THE ESSELTINE DRAIN: ADDENDUM REPORT—BOOK 3

SECOND ONSITE MEETING 25 JANUARY 2017
LANDOWNER QUESTIONS AND COMMENTS

RC SPENCER ASSOCIATES INC.
Consulting Engineers

Project No.: 14-425

Figure 3: Frank Mastronardi – Property Drainage Route

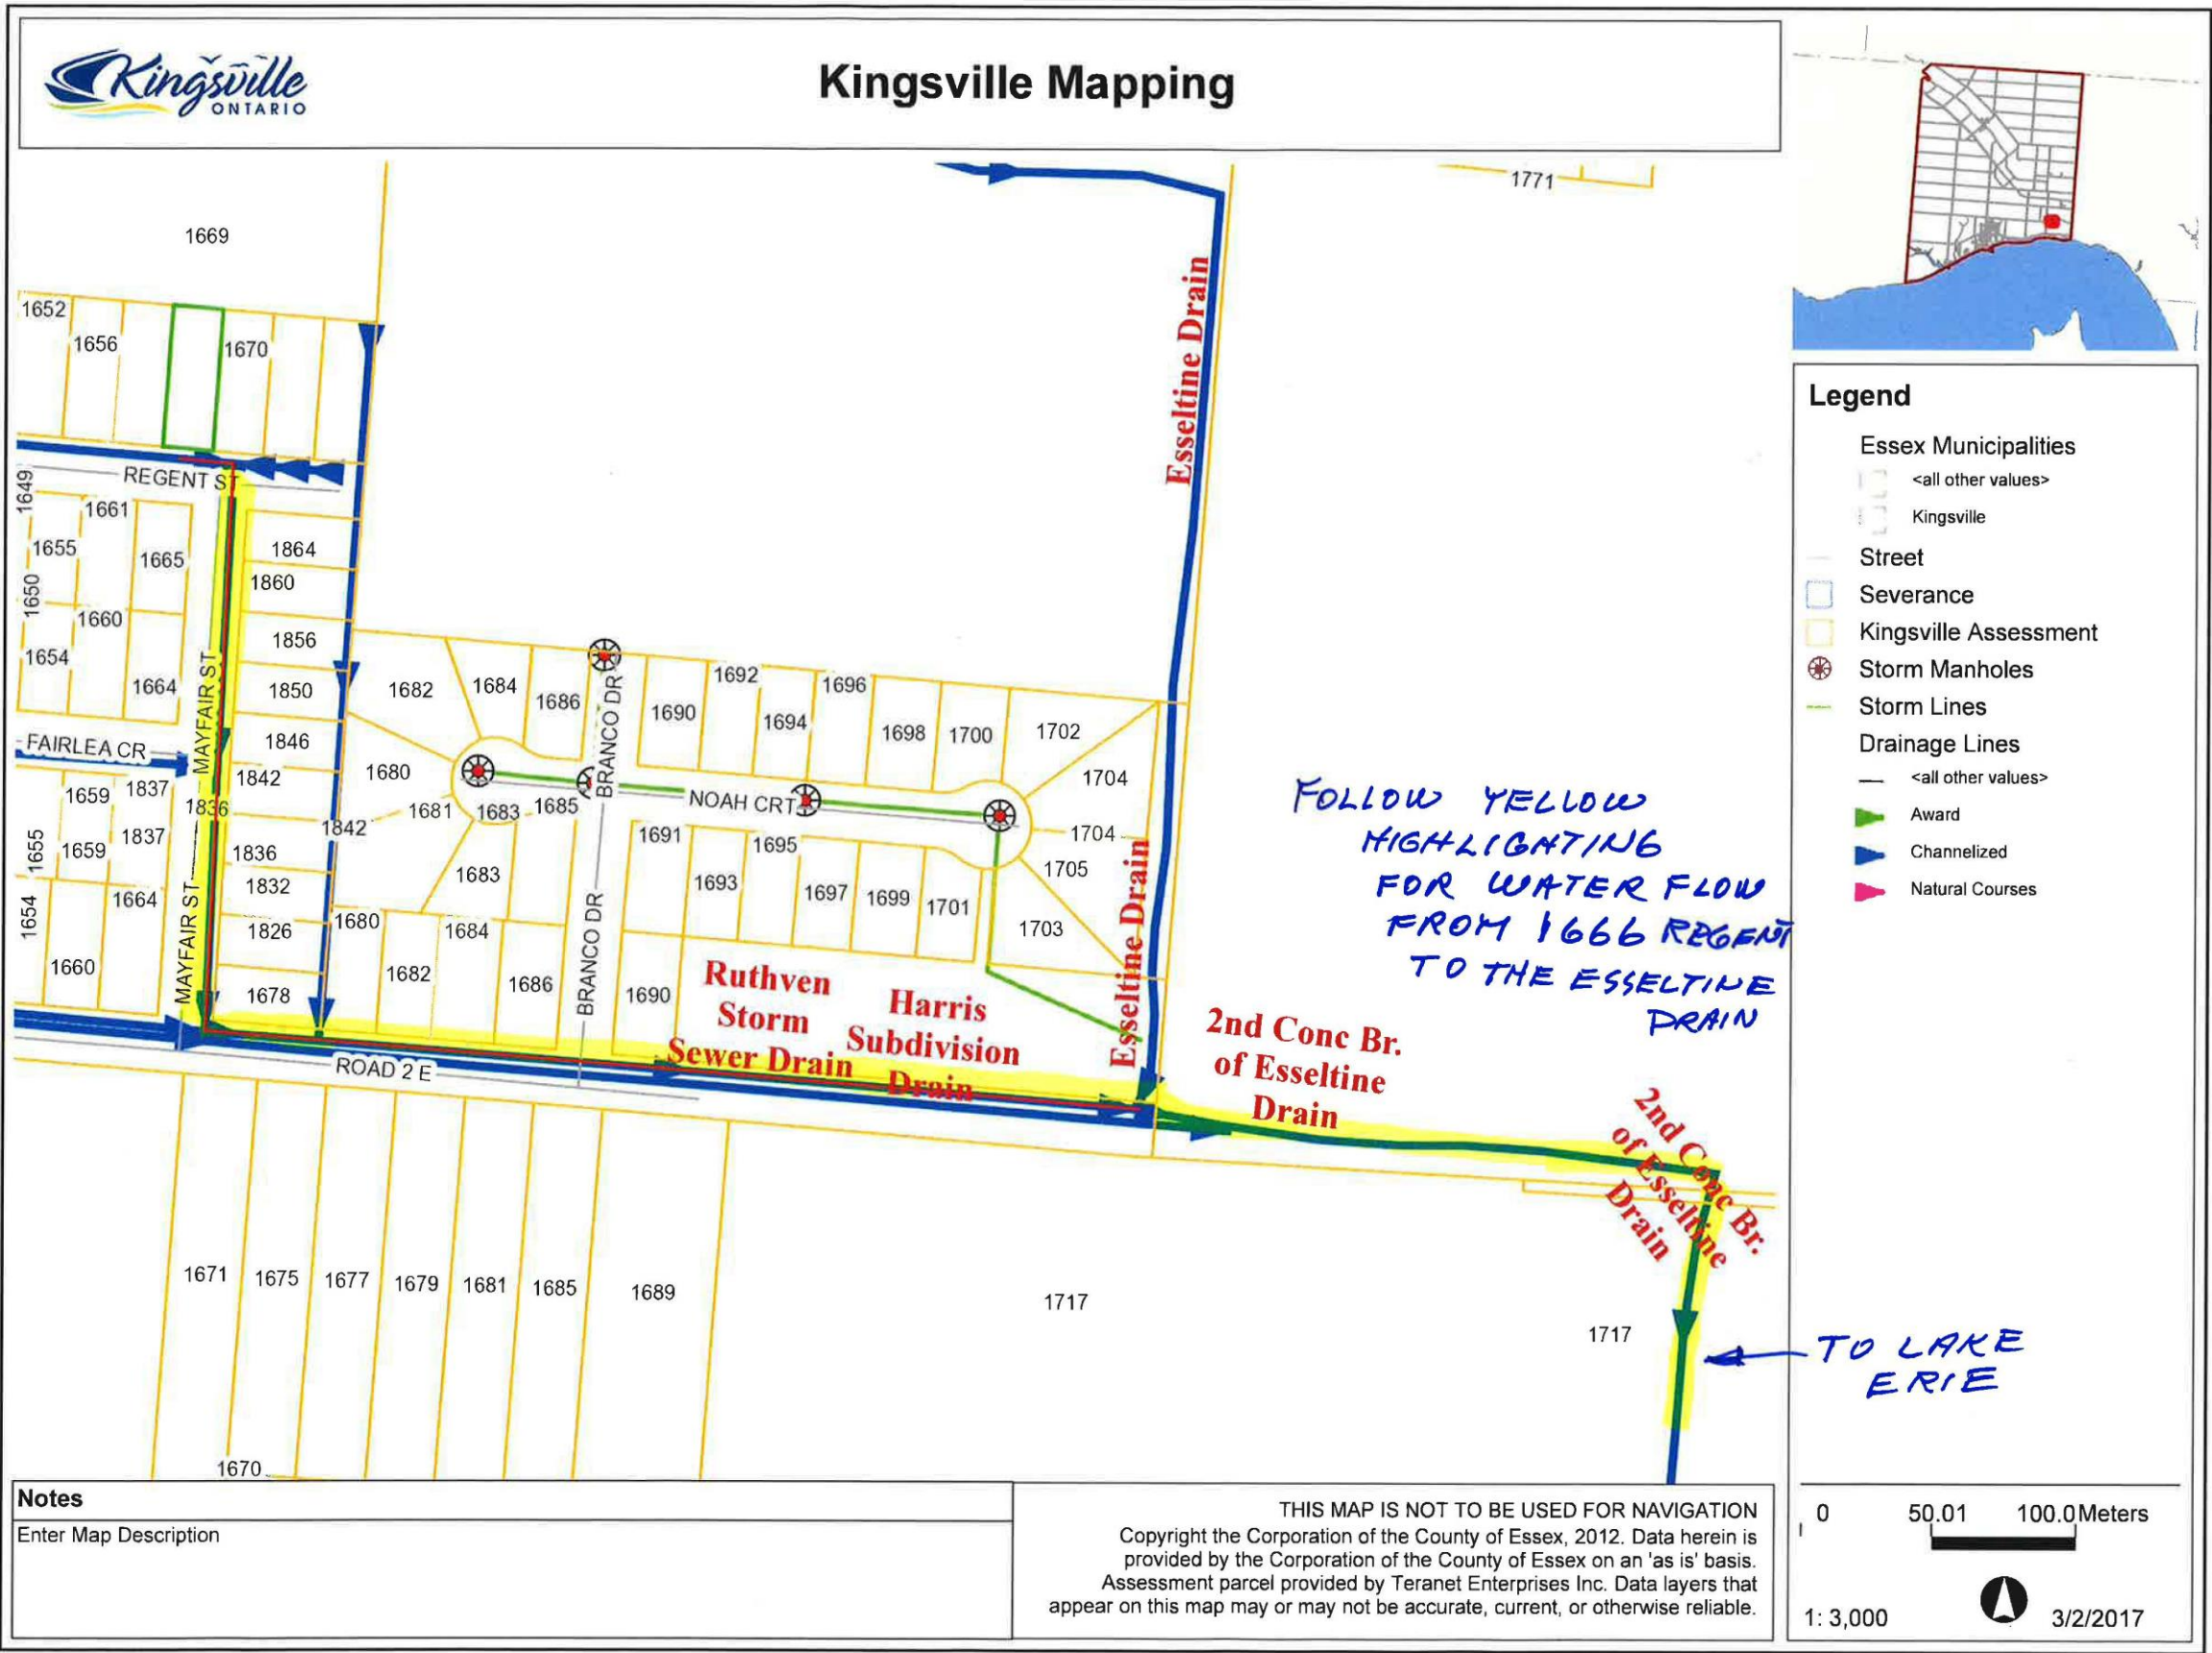
4)	Frank Mastronardi 1666 Regent Street Roll No.: 290-36100	January 25, 2017	1) The storm sewers on Regent Street do not flow into Esseltine, there is water ponding on my property?	1) We have attached a map showing how the water from your property drains into the Esseltine drain through storm sewer systems. Your property is outlined in green and the path the water takes to get to the Esseltine Drain is highlighted in red. - Please see page 12 (Figure 3) for attachment

Figure 4: Jim Jensen – Ravine Cross Section

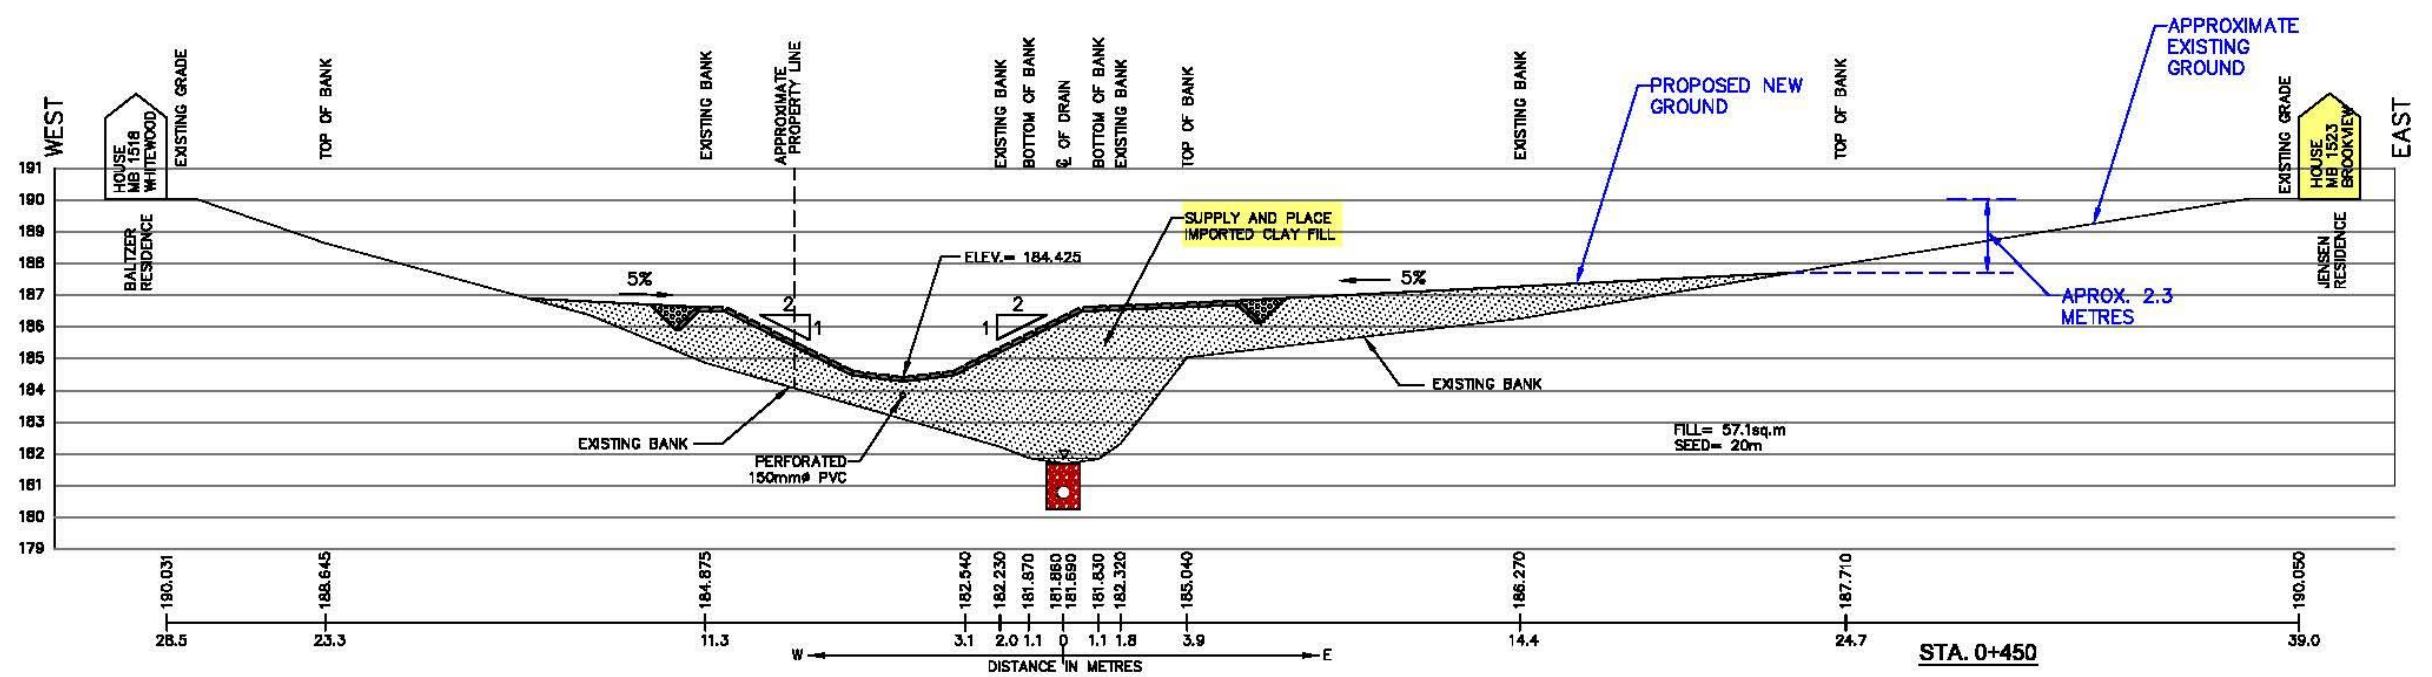
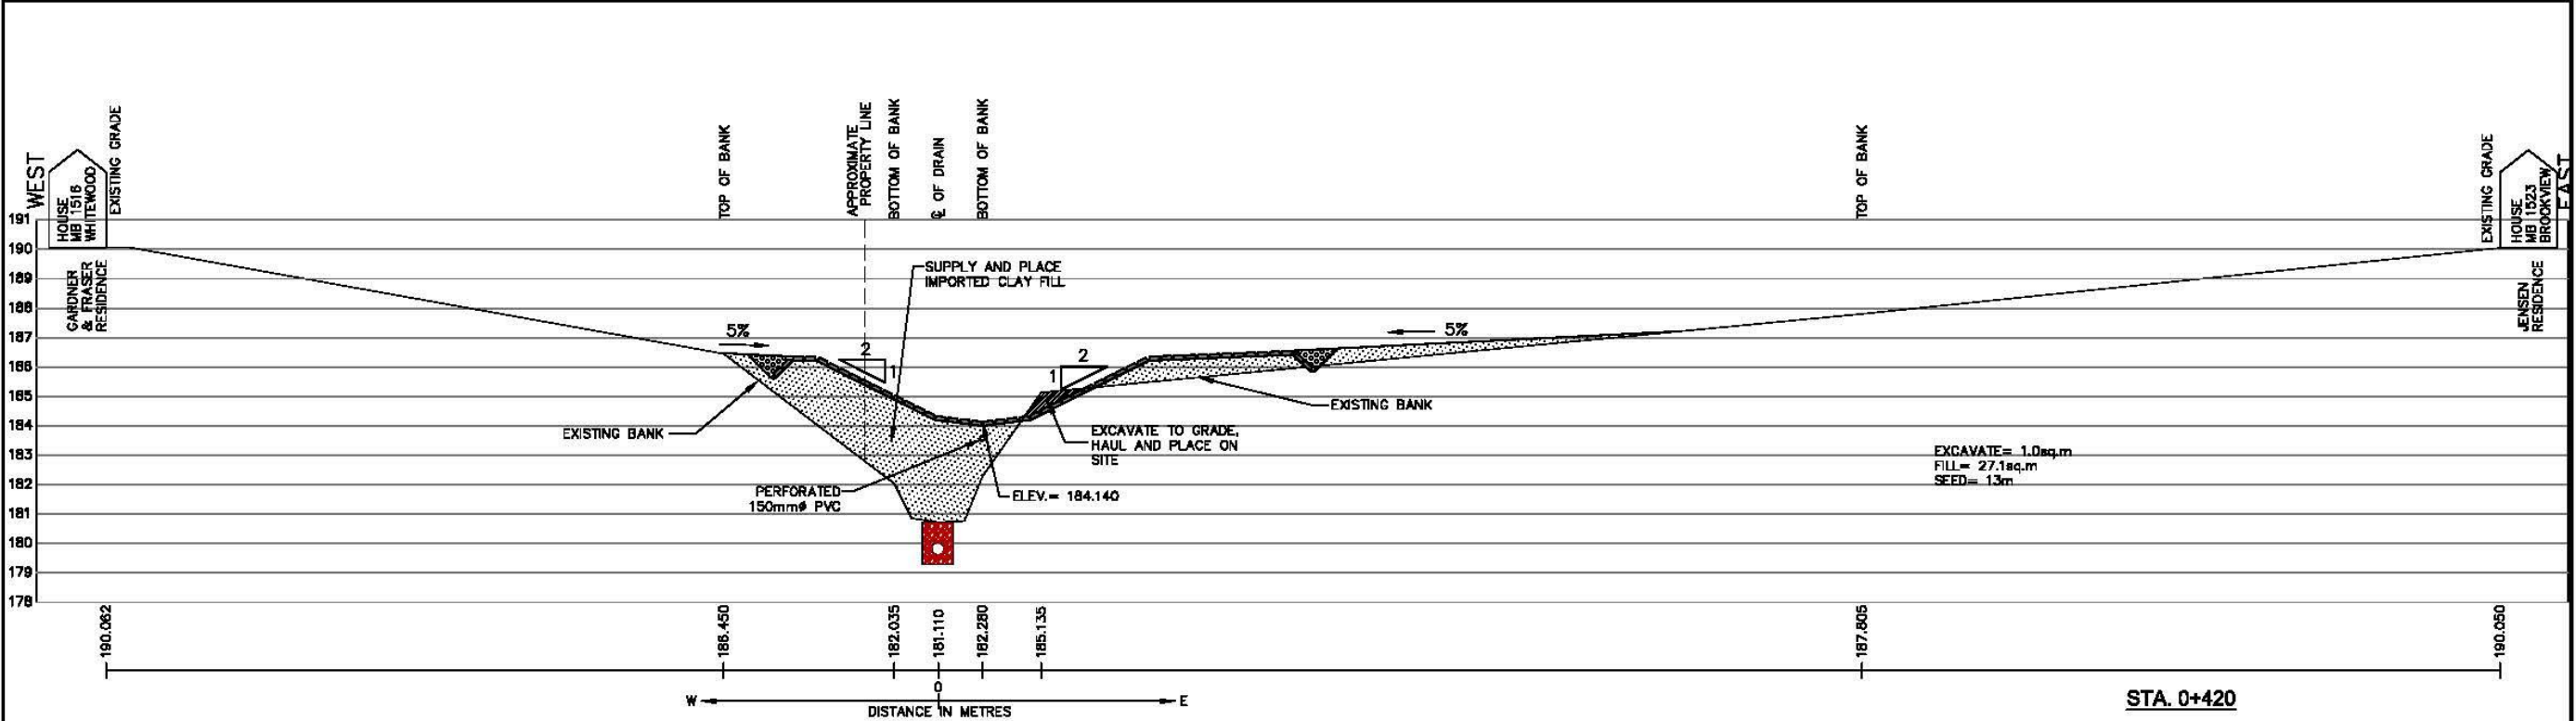
ENTRY NO.	NAME	DATE	LANDOWNER COMMENTS	ENGINEER'S RESPONSE (RC SPENCER ASSOCIATES)
7)	Jim Jenson 1523 Brookview Drive Roll No.: 290-08800	January 25, 2017	1) Can limits of the drain be marked out?	1) When the drain goes to construction, the contractor or a survey company will be hired to provide the layout of the proposed drainage works. The layout will show the limits of the drain with the elevation of fill or cut. In the meantime, we provide you with this cross section showing the approximate conditions of your property. As shown in the cross section, the limit of the drain is approximately 16 metres from your house and 2.3 metres below the finished grade of the house. - Please see page 13 (Figure 4) for attachment.
